<b>Delegated Report</b>	Analysis shee	et	Expiry Date:	14/05/2018		
	N/A		Consultation Expiry Date:	14/06/2018		
Officer Sofie Fieldsend		Application N 2018/1341/P	umber(s)			
Application Address Flat A, 43 Hampstead High Street		Drawing Num	bers			
London NW3 1QG		See draft decision notice				
PO 3/4 Area Team Signatu	re C&UD	Authorised Of	ficer Signature			
Proposal(s)  Erection of two storey rear extension at first and second floor level and conversion of existing 3 bed flat to provide 2 x 1 bed flats (Class C3).						
	Had an appeal not been lodged against non-determination, planning permission would have been refused					
Application Type: Full Perm	Full Permission

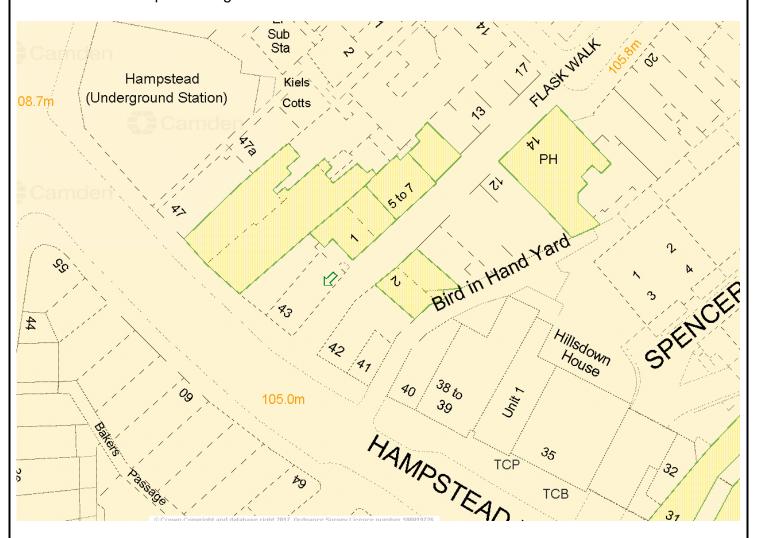
This proposed extension, taken together with the crucial views down Flask Walk, would obscure and distort the architecture of the cottages in Flask Walk, and harm the character of this archetypal corner of Hampstead. It really must not be allowed to damage this National asset. Please refuse.
	Councillor Stark raised the following objection:
Councillor Stark:	As one of the Hampstead Town ward councillors I would object to the above planning application. The proposed extension and infilling of this important corner of Hampstead Village will obscure the view of the Grade II listed 1-3 Flask Walk and destroy the openness given by the setting back of this building on the corner of Flask Walk and Hampstead High Street. The planning application if granted will also eradicate the view of the flank roof elevation and chimney stack of 1 Flask Walk. I am also concerned that there will be a loss of light and amenity into the 1 Flask Walk flank roof window. Please see the attached marked up photograph.

The aspects which I have described work with others to create the unique character of Hampstead. It is a heritage which we have a responsibility to pass on and not destroy. It cannot be re-produced once lost.
